PENNSYLVANIA ELECTRIC COMPANY
THREE MILE ISLAND NUCLEAR STATION UNIT 1

Operating License No. DPR-50
Docket No. 50-289
Technical Specification Change Request No.30

TECHNICAL SPECIFICATION CHANGE REQUEST NO. (Proposed Change 47)

The licensee requests that the attached changed pages replace pages 2-1, 2-2, 2-3, 2-5, 2-6, 2-7, 2-9, 3-16, 3-34, 3-35, 3-36, figures 2.1-1, 2 & 3, figures 2.3-1 & 2, and figures 3.5-2A thru F of the existing Technical Specifications.

Figure 2.1-1

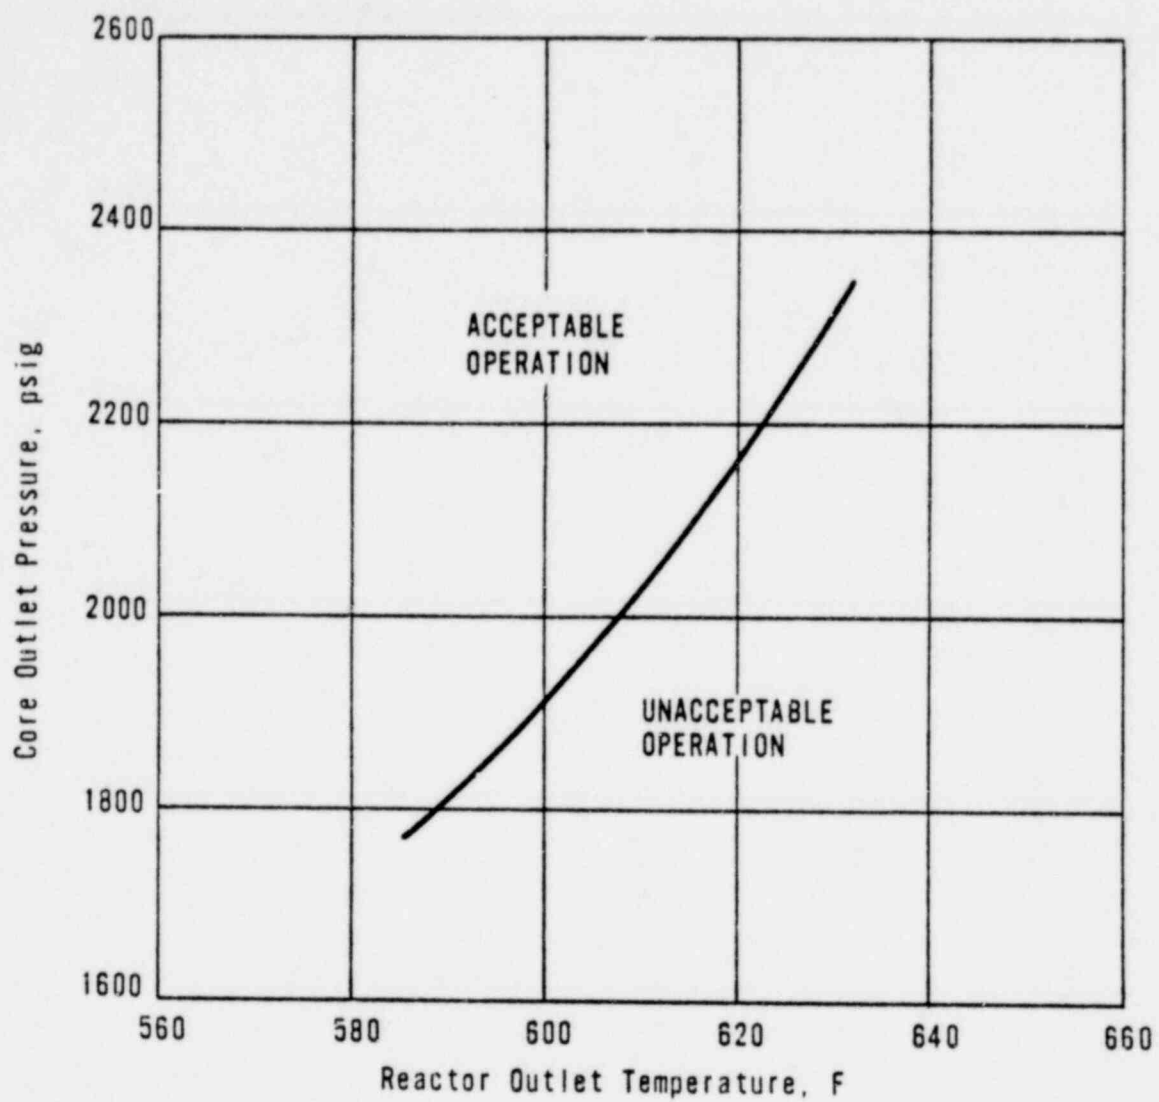
Changes to the present technical specifications are necessary as a result of: the effects of introducing 56 fresh batch 4 fuel assemblies combined with relocation of once burned Batch 2 and 3 fuel assemblies; use of the B&W-2 CHF correlation with a 95/95 confidence level, and extended pressure application to 1750 psi; use of a RC flow equal to 106.5% of Cycle 1 design flow; and ECCS Final Acceptance Criteria (FAC).

The curve presented in Figure 2.1-1 represents the conditions at which a minimum DNBR of 1.3 is predicted for the maximum possible thermal power (112 percent) when the reactor coolant flow is 139.8×10^6 lbs/h, which is less than the actual flow rate for four operating reactor coolant pumps. This curve is based on the following nuclear power peaking factors (2) with potential fuel densification effects;
